PLANT SAFETY EVALUATION

BEAVER VALLEY POWER STATION UNIT 2

VANTAGE 5H

APPENDIX B Recommended Modifications to Beaver Valley Unit 2 UFSAR

FIGURE 4.2-1
FUEL ASSEMBLY CROSS SECTION
17 x 17
BEAVER VALLEY POWER STATION-UNIT 2
FINAL SAFETY ANALYSIS REPORT

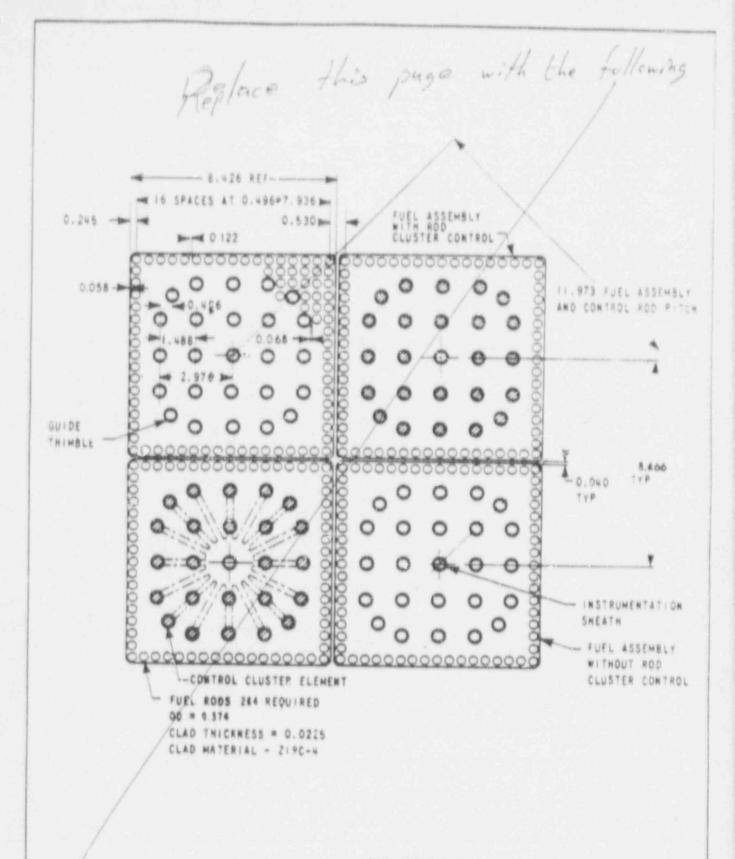
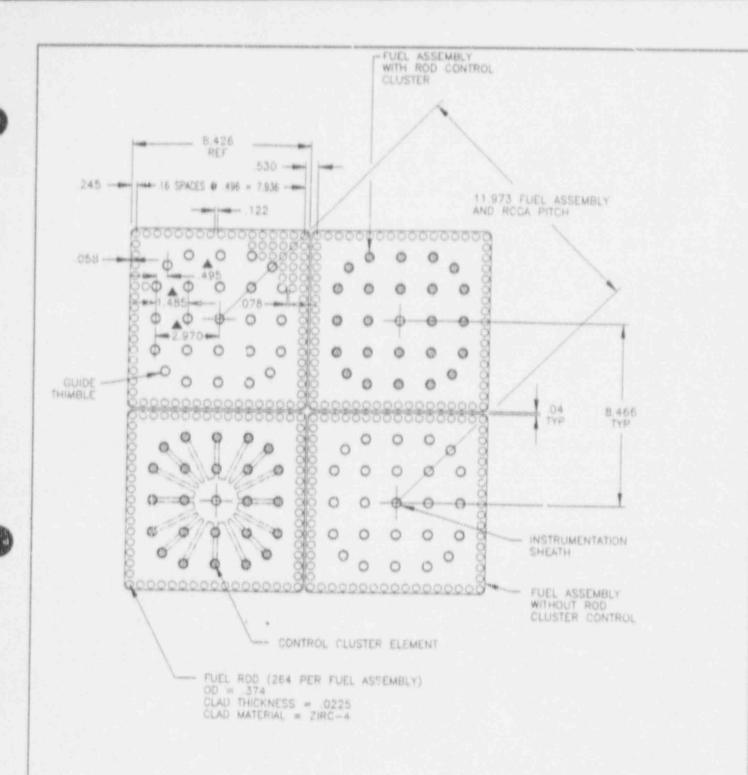
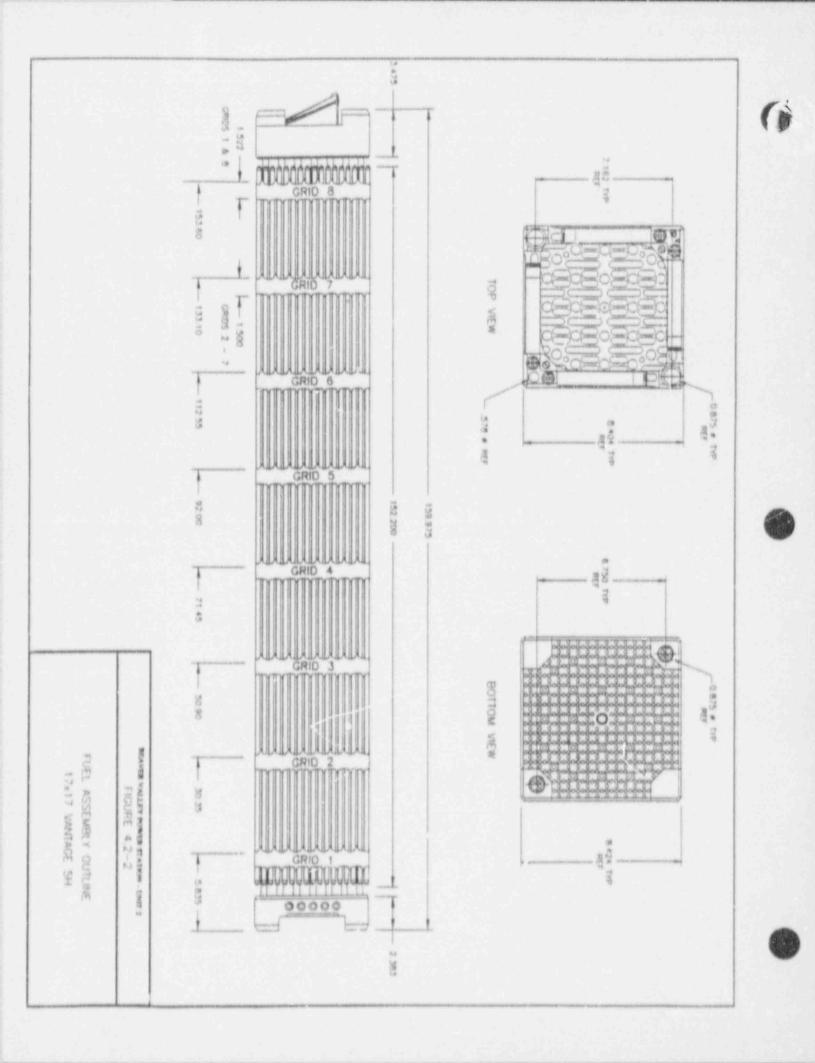
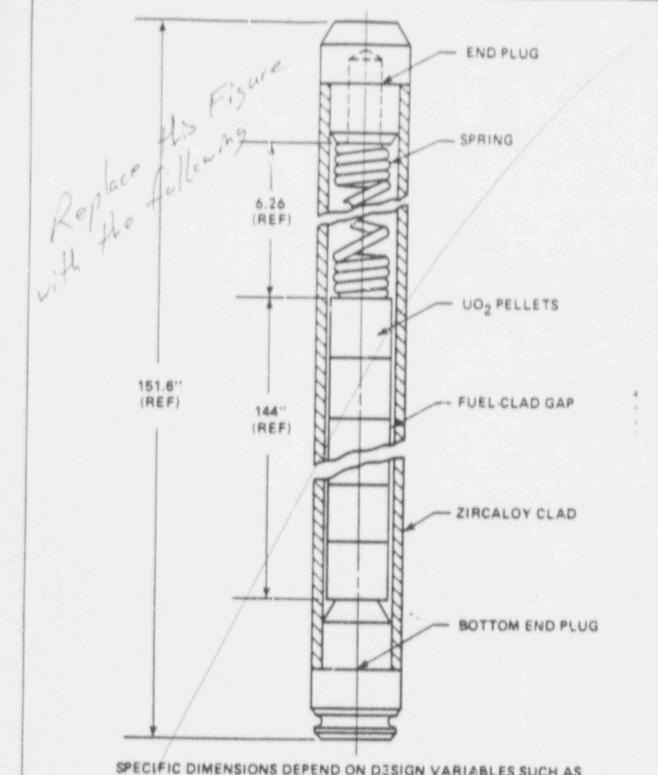
FUEL ASSEMBLY ORCAS SECTION 17x17 VANTAGE 5H Replace this Figure with 8 8 117. TOP VIEW

FIGURE 4.2-7
GUIDE THIMBLE TO BOTTOM
NOZZLE JOINT
BEAVER VALLEY POWER STATION-UNIT 2
FINAL SAFETY ANALYSIS REPORT

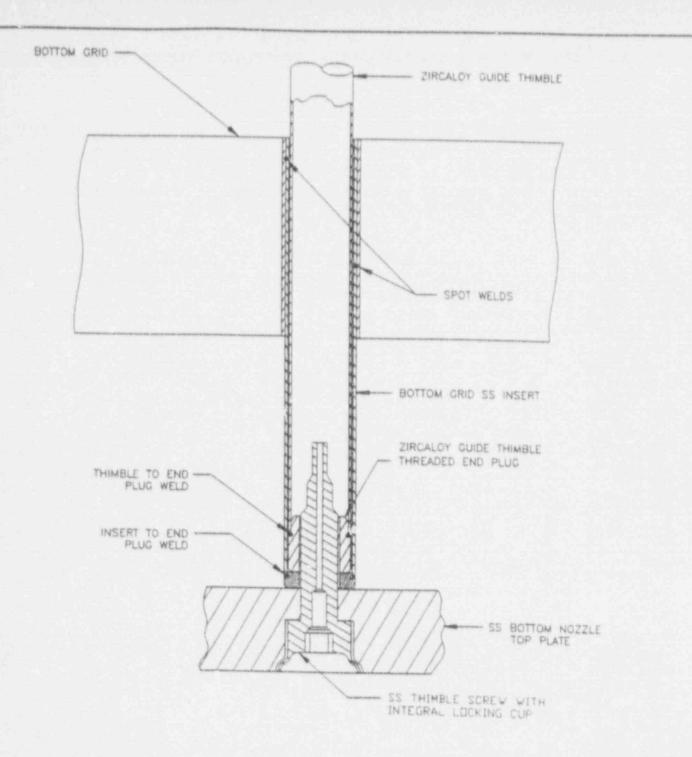
Replace this Figure with the following. ZIACALOY THIMBLE BOTTOM GRID ASSEMBLY -SPOT WELD (4) STAINLESS STEEL INSERT -ZIRCALOY THIMBLE STAINLESS STEEL LOCK PIN BOTTOM NOZZLE STAINLESS STEEL GUIDE THIMBLE SCREW

FIGURE 8-4-6
MEASURED VERSUS PREDICTED CRITICAL
MEAT FLUX - WRB-1 CORRELATION

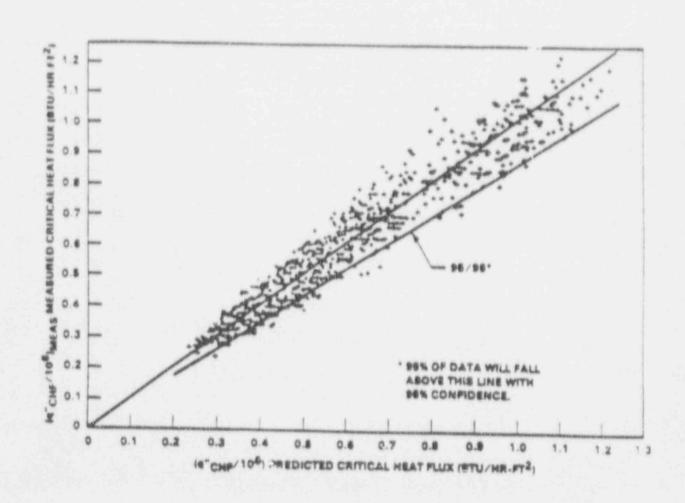
REPLACE FIGURE 4.4-1 WITH NEW FIGURE 4.4-1.

VOID FRACTION VS.
THERMODYNAMIC QUALITY
BEAVER VALLEY POWER STATION-UNIT 2
FINAL SAFETY ANALYSIS REPORT

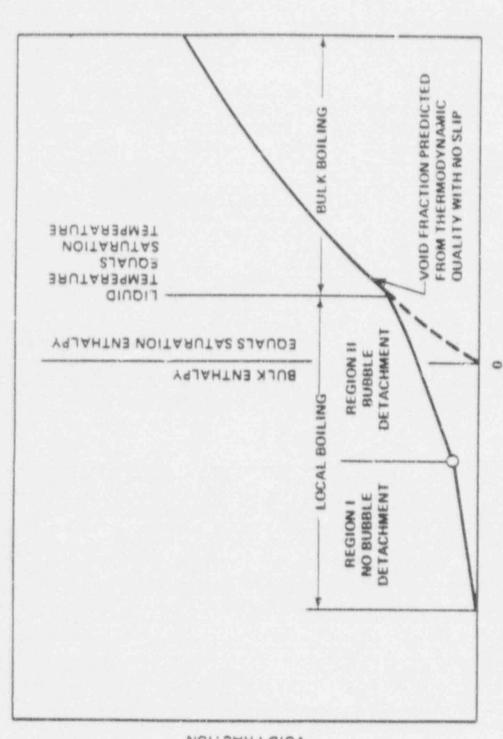
DELETE THIS PAGE

FIGURE 15.3-1
FLOW TRANSIENTS FOR
PARTIAL LOSS OF FLOW,
THREE LOOPS IN OPERATION,
ONE PUMP COASTING DOWN
BEAVER VALLEY POWER STATION-UNIT 2
FINAL SAFETY ANALYSIS REPORT

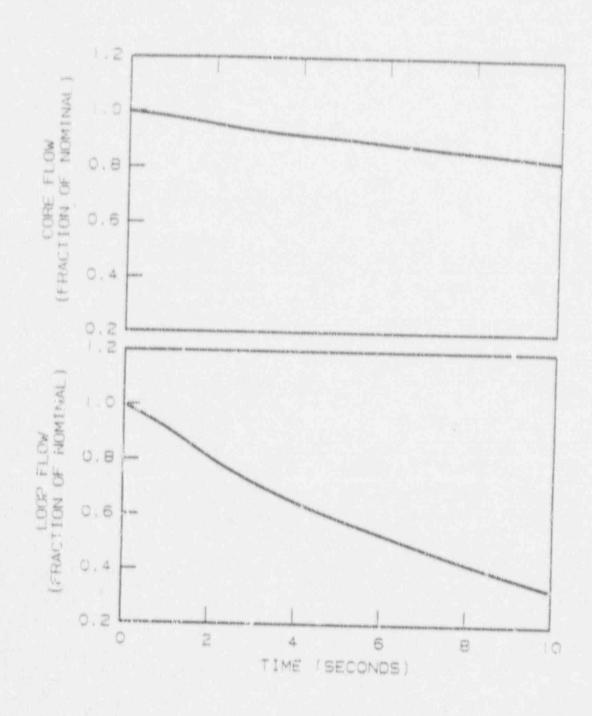
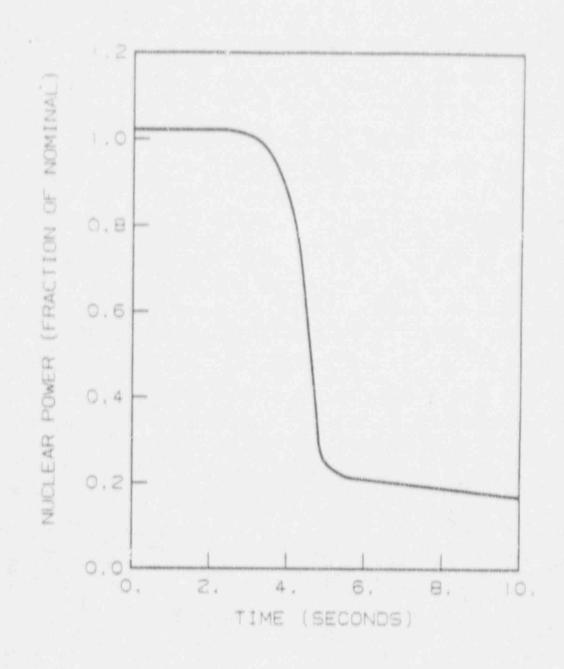
pelele this Page

PIGURE 15.3-4

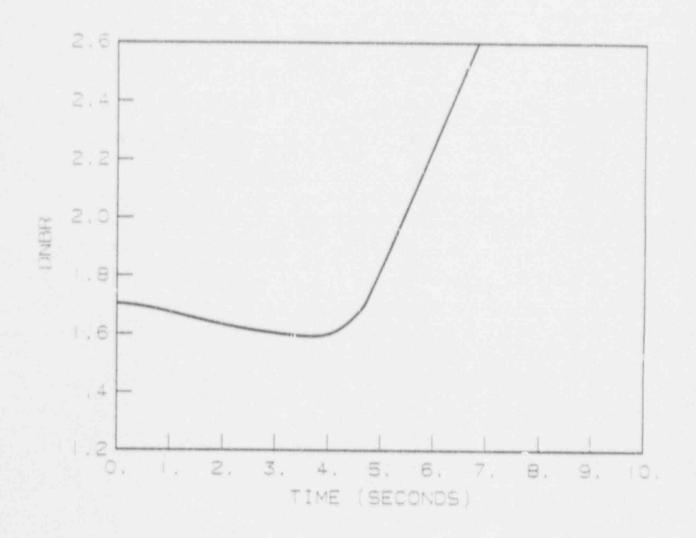
Replace Figure with following Page

FIGURE 15.3-9

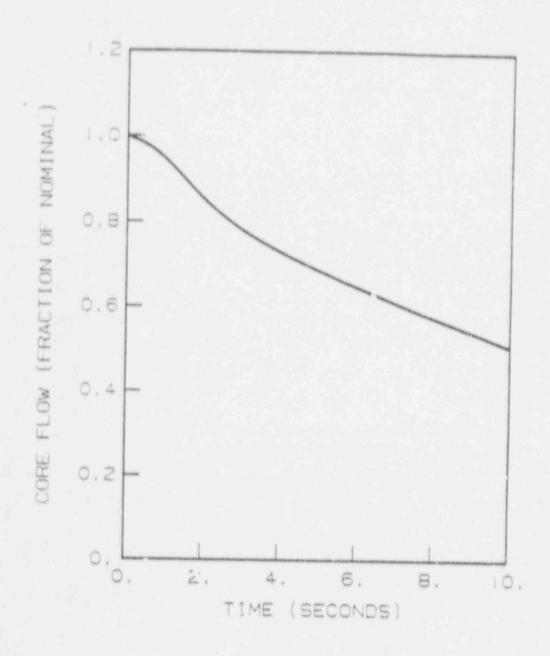
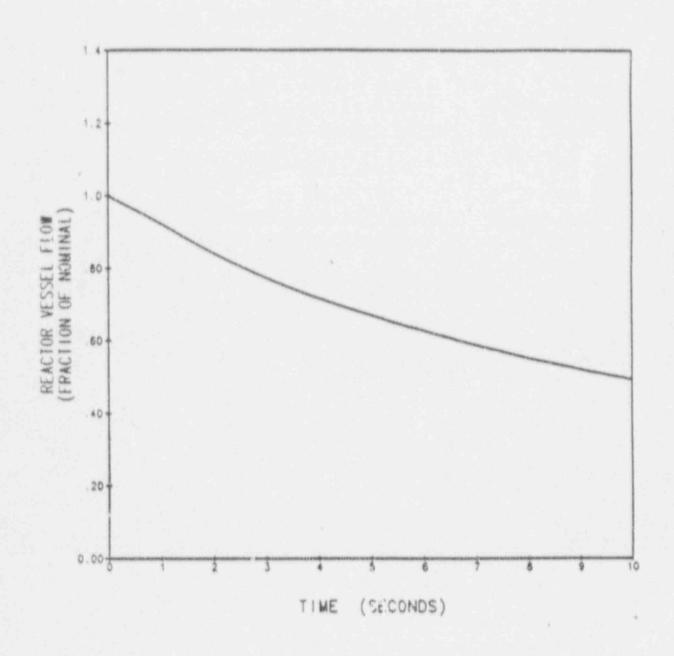
Replace Figures with following Page

FIGURE 15.3-10

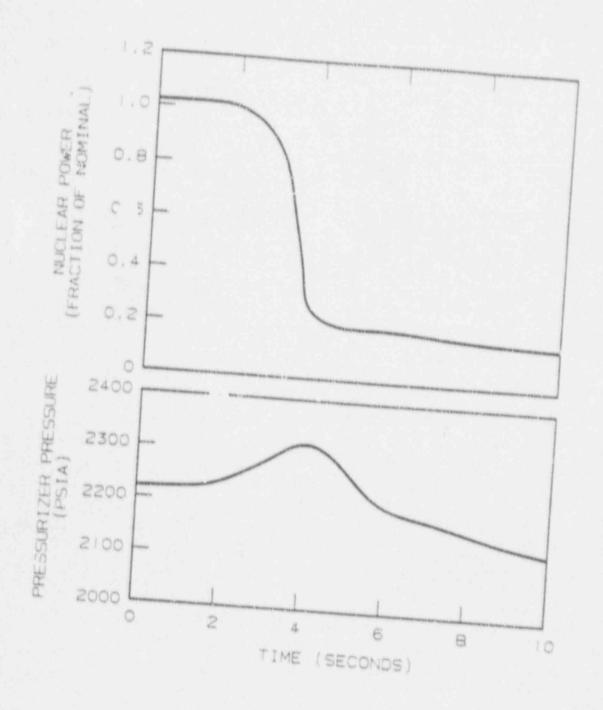
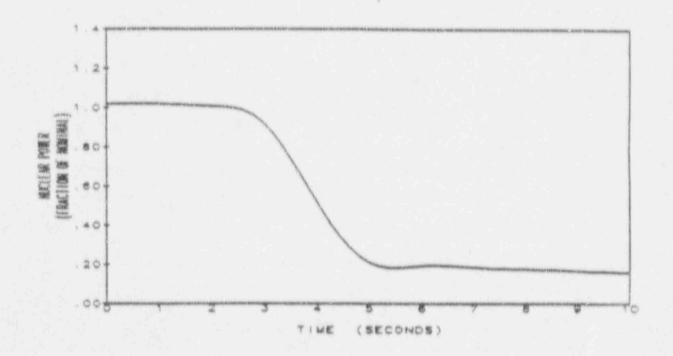
Replace Figures with following Page

FIGURE 15.3-11
AVERAGE AND HOT CHANNEL HEAT FLUX
TRANSIENTS FOR THREE LOOPS IN
OPERATION, THREE PUMPS COASTING
DOWN, COMPLETE LOSS OF FLOW
BEAVER VALLEY POWER STATION-UNIT 2
FINAL SAFETY ANALYSIS REPORT

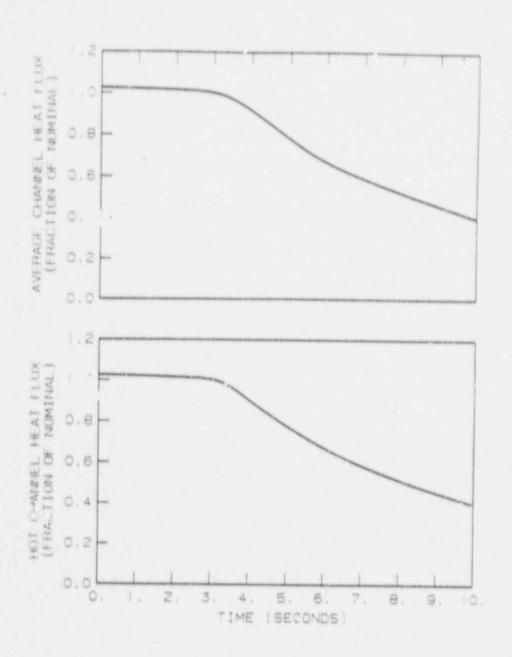
Replace Figure with following Page

Figure 15.3-17

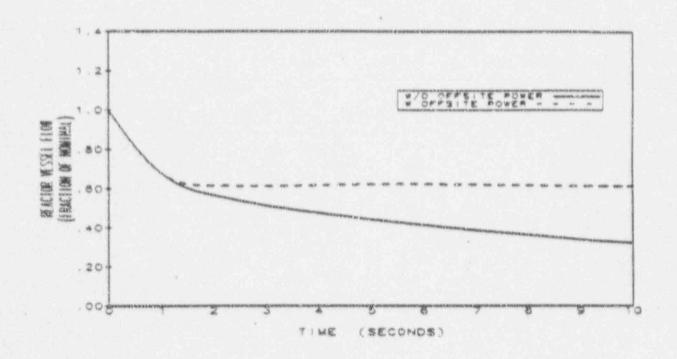
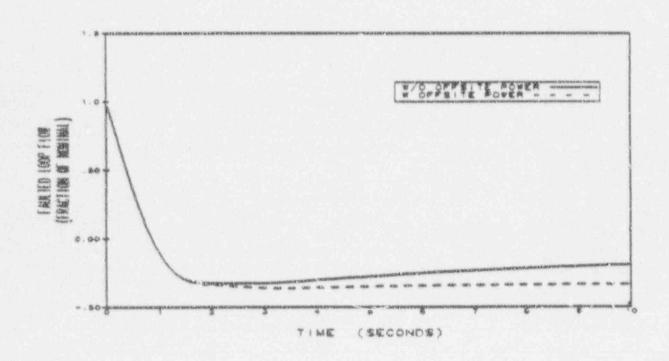
Replace Figure with following Page

FIGURE 15.3-19
NUCLEAR POWER TRANSIENT,
AVERAGE AND HOT CHANNEL HEAT
FLUX TRANSIENTS FOR THREE LOOPS
IN OPERATION, ONE LOCKED ROTOR
BEAVER VALLEY POWER STATION-UNIT 2.
FINAL SAFETY ANALYSIS REPORT

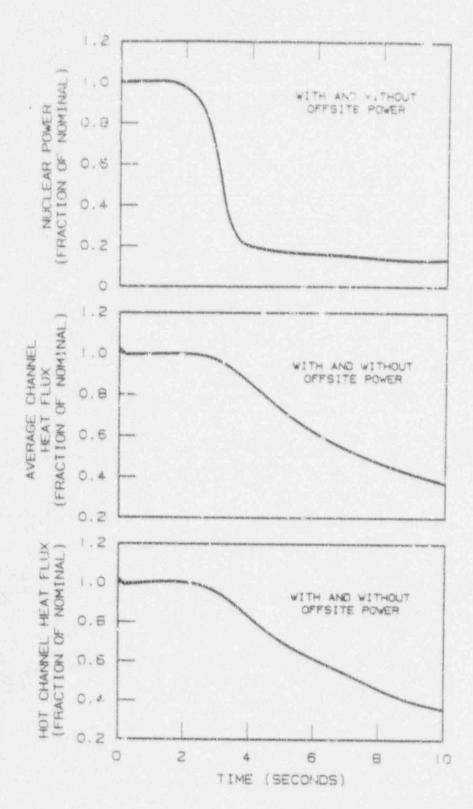
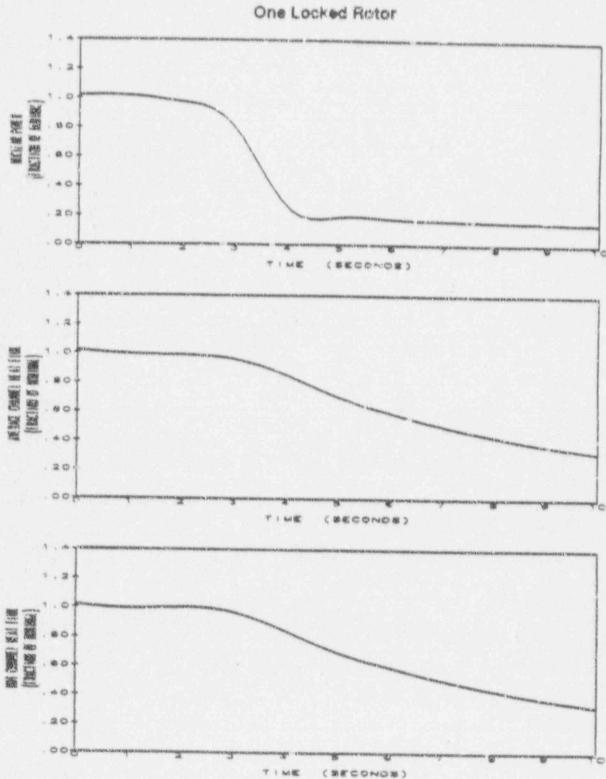
Replace Figures with following Page
